SB, New EMI-Filter, D 20, D 30, W 70, W 70P, W 250P, S 13, S 26, S 36, 2024-06

New EMI filter replaces old one.

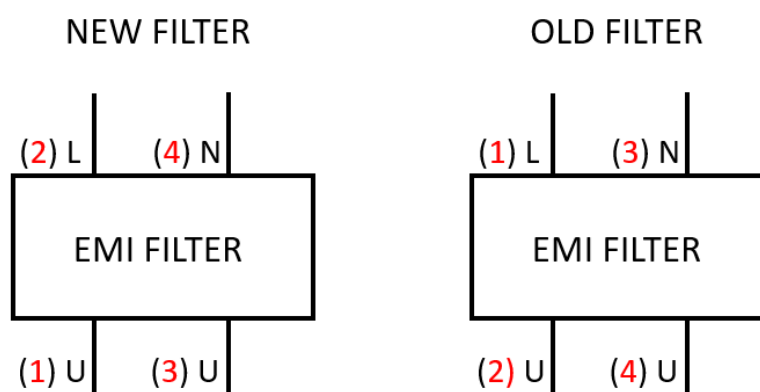
Old number: 590427201

New number: **548068901**

The pinout of the new EMI filter is different from the old one. Pay attention to which filter you are installing.

Refer to complete electric schematics in the updated workshop manuals.
